Agenda Item # 13

SUB-002959-2024

Moffett-Wolf Ridge Subdivision

APPLICATION NUMBER 13 DATE June 20, 2024

DETAIL SITE PLAN

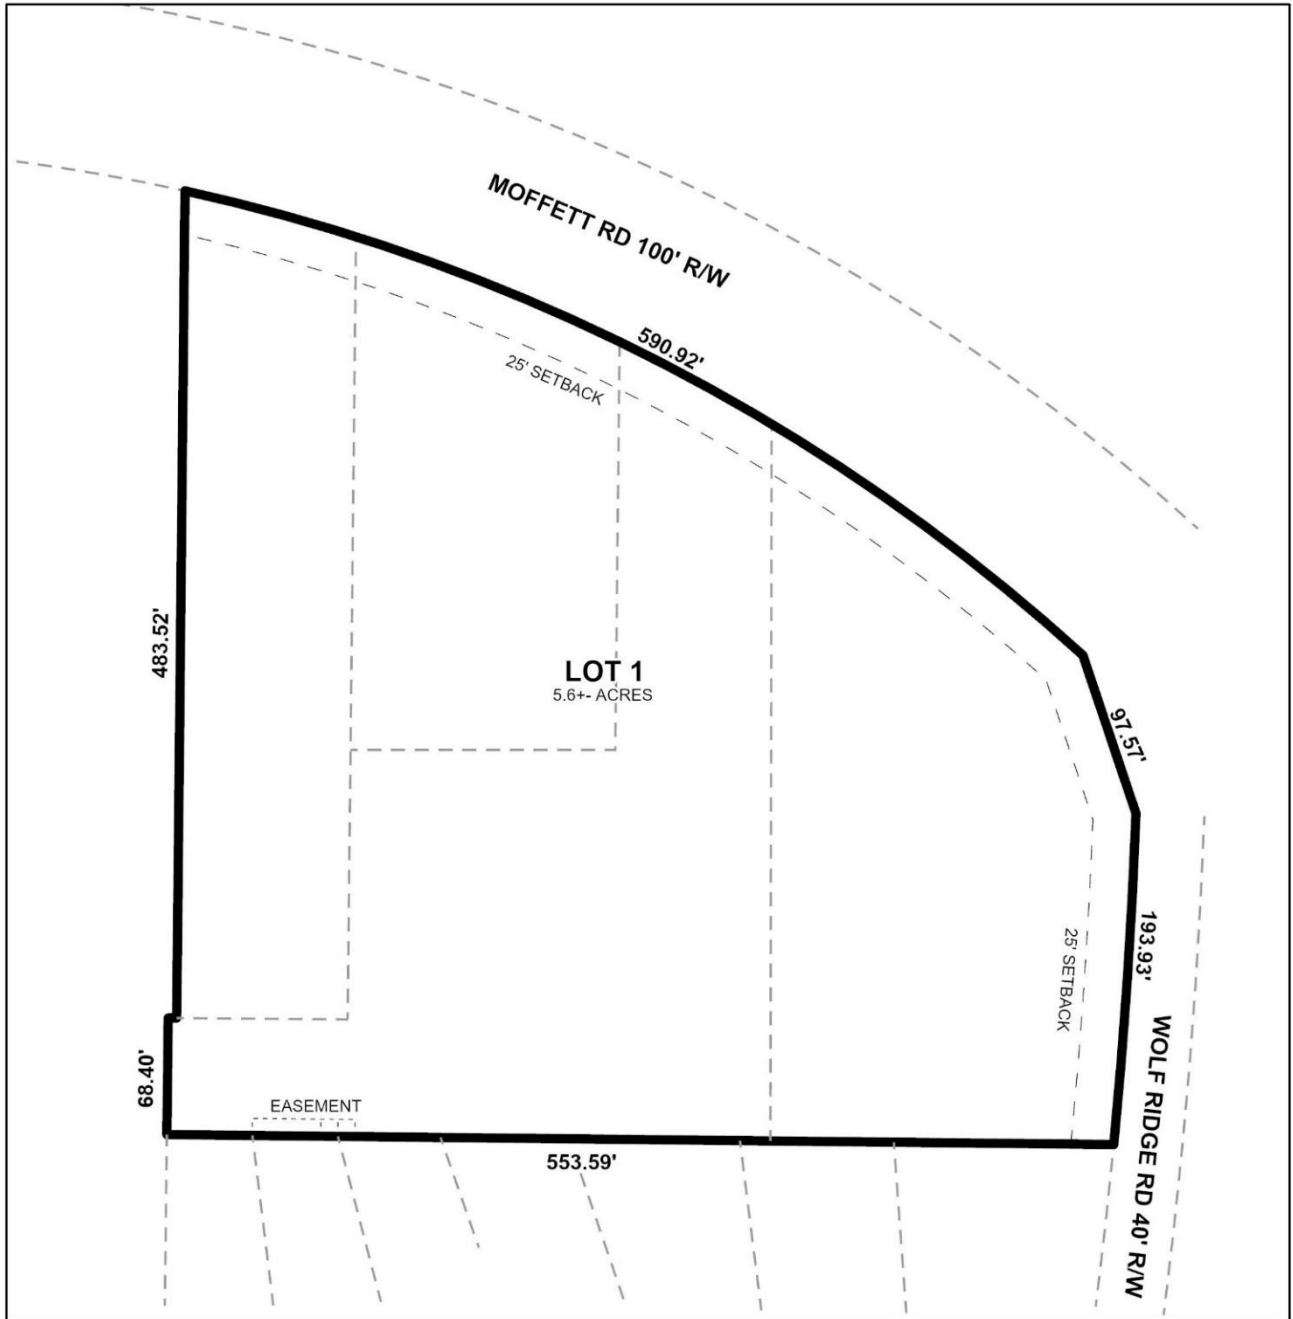
The site has frontages along Moffett Road and Wolf Ridge Road. This portion of Wolf Ridge Road is a minor street with curb and gutter, and has an existing 40-foot right-of-way. Section 6.B.9. of the Subdivision Regulations typically requires streets with curb and gutters to have a right-of-way of 50-feet; however, the Planning Commission has waived the dedication requirement for this property in 2001 and in 2006 when the site was the subject of a Subdivision application. Review of the Picardy Estates Subdivision plat to the South of the subject site, recorded in 1963, shows that the 40-foot wide portion of Wolf Ridge Road was to be a "service road" for the proposed adjacent 100-foot wide Wolf Ridge Road Extension, a part of the Major Street Plan that has since been removed. Therefore, a waiver of Section 6.B.9. may be appropriate. Moffett Road is a major street on the Major Street Plan, and is depicted as having an existing compliant right-of-way of 100-feet, making no dedication necessary.

The lot, as proposed, exceeds the minimum size requirements for lots served by public water and sanitary sewer in a B-3 Suburban district, and is appropriately labeled in square feet and acres on the preliminary plat. This information should be provided on the Final Plat, if approved; or provision of a table on the Final Plat with the same information will suffice.

A 25-foot front yard setback is illustrated along both street frontages, as required by Section 64-2-14.E. of the Unified Development Code (UDC) for lots in the B-3 Suburban District, and should be retained on the Final Plat, if approved.

1. Either obtain demolition permits for all existing structures prior to the signing of the Final Plat, or submit an application for a Major Modification of a Previously Approved Planned Unit Development;

2. Retention of the existing right-of-way along Moffett Road and Wolf Ridge Road;
3. Retention of the lot size in both square feet and acres, or provision of a table on the Final Plat with the same information;

4. Retention of the 25-foot minimum front yard setback along both Moffett Road and Wolf Ridge Road on the Final Plat;
5. Compliance with the 2006 rezoning amendment conditions, until and unless the property is rezoned;
